PREVOST

**SAFETY
RECALL**

SR23-05

DATE :	September 2023	SECTION :	23 ACCESSORIES
SUBJECT:	AFSS OPTICAL SENSOR CORROSION

AREA OF THE SENSOR BACKSIDE THAT MUST BE FREE OF CORROSION (WHITE ALUMINUM OXIDE POWDER)

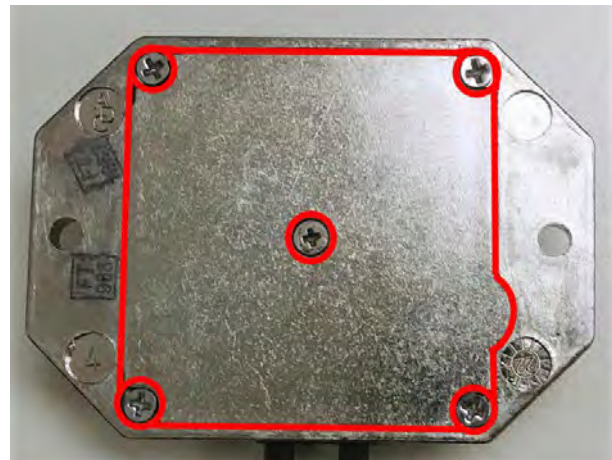
4. Inspect the backside of the sensor looking for sign of corrosion at the cover seam.

- Look for excess of aluminum oxide, a white (sometimes greenish) dusty looking material.
- If aluminum oxide is found and it is touching the seam of the backside cover, the sensor must be replaced.
- Superficial black spots (small crater) are ok unless they create a noticeably deep crevice at the seam area.

5. If the sensor is corroded, it must be replaced. Unplug the sensor two connectors under the bracket.

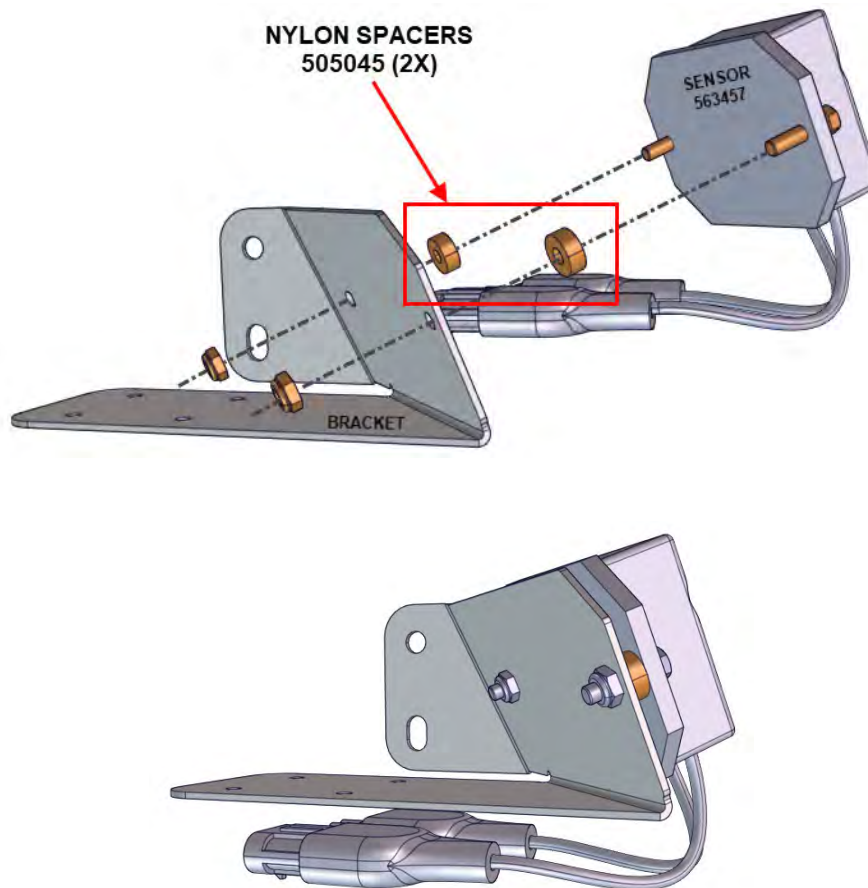
7. Reinstall (or install a new sensor, as required) the sensor on the bracket adding the supplied **505045** nylon spacers between the sensor and the bracket.

- Reuse mounting hardware (screws and nyloc nuts).

SENSOR REPLACEMENT GUIDE

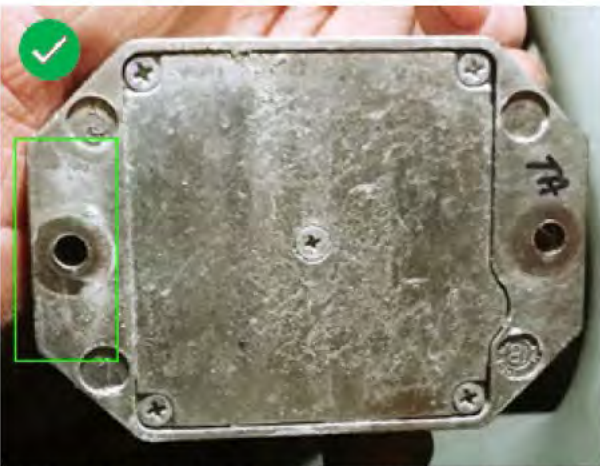
SUPERFICIAL BLACK SPOTS ARE OK - CLEAN & REINSTALL

WHITE CORROSION AT ONE EDGE - REPLACE

WHITE SPOT FORMING BUT NOT TOUCHING THE COVER SEAM - CLEAN & REINSTALL

WHITE CORROSION ALL AROUND THE COVER - REPLACE

SENSOR COVER DIRTY AND ROUGH BUT SMALL WHITE SPOT NOT TOUCHING THE EDGE - CLEAN & REINSTALL

BACK SIDE COVERED BY CORROSION - REPLACE
